<b>A&amp;B IRRIGATION DISTRICT,</b>	)	
	)	CASE NO. 07-665
Petitioner,	)	
	)	
vs.	)	<b>AFFIDAVIT OF CHARLES</b>
	)	<b>E. BROCKWAY, P.E., Ph.D. IN</b>
<b>DAVID R. TUTHILL, JR.,</b> in his official	)	<b>OPPOSITION TO RESPONDENTS'</b>
capacity as director of the Idaho Department of	)	<b>MOTION TO DISMISS</b>
Water Resources, and <b>THE IDAHO</b>	)	
<b>DEPARTMENT OF WATER RESOURCES,</b>	)	
	)	
Respondents.	)	
_____	)

**SNAKE RIVER PLAIN AQUIFER  
MODEL SCENARIO:**

***THE SOURCES OF DRAWDOWN AT A&B***  
***“A&B Scenario”***

## Appendix 1 HDR Comments

**Figure 2. Drawdown at A&B due to pumping within the A&B service area only.**

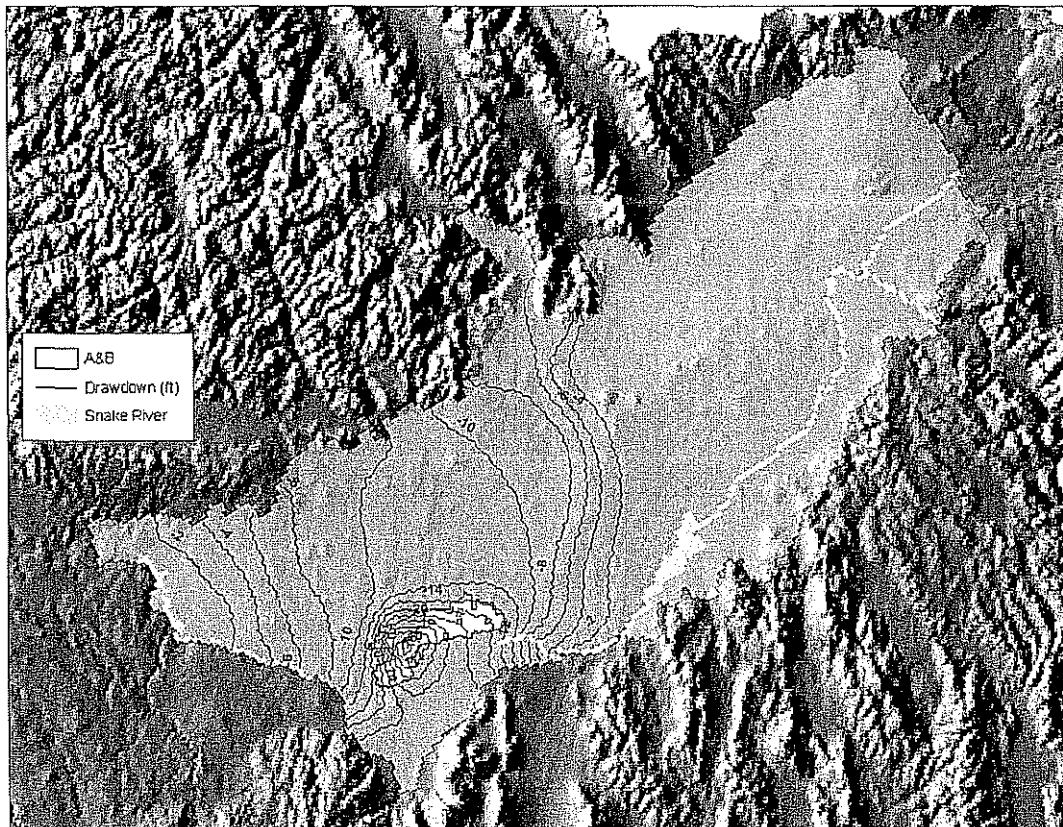
We understand that drains are not included in the super-position analysis. If this is the case, please remove the drain cells from Figures 2 to 4.

The predicted drawdown shown in Figures 2 to 4 exceeds the observed drawdown in the aquifer at areas near A&B Irrigation District and south of the District. Please explain these results.

Accept.

Accept. I will add an explanation to the summary section.

The statistic of 13 feet in the text under the A&B Pumping section does not match the statistic in Table 1.

Accept.

**Figure 3. Drawdown at A&B due to all other ground water irrigation.**

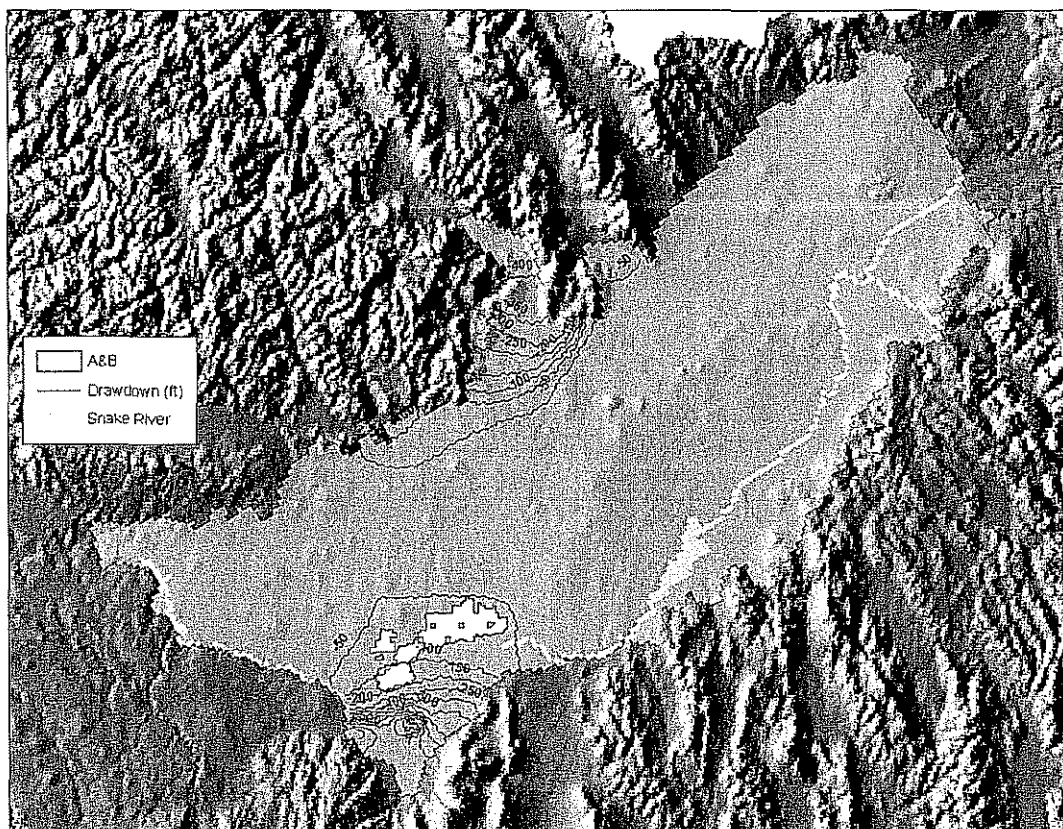
The scenario results in Figure 3 seem to show boundary effects in the Oakley Fan and Big Lost River area. Please explain.

Accept. We will add a paragraph to that effect in the "others" scenario.
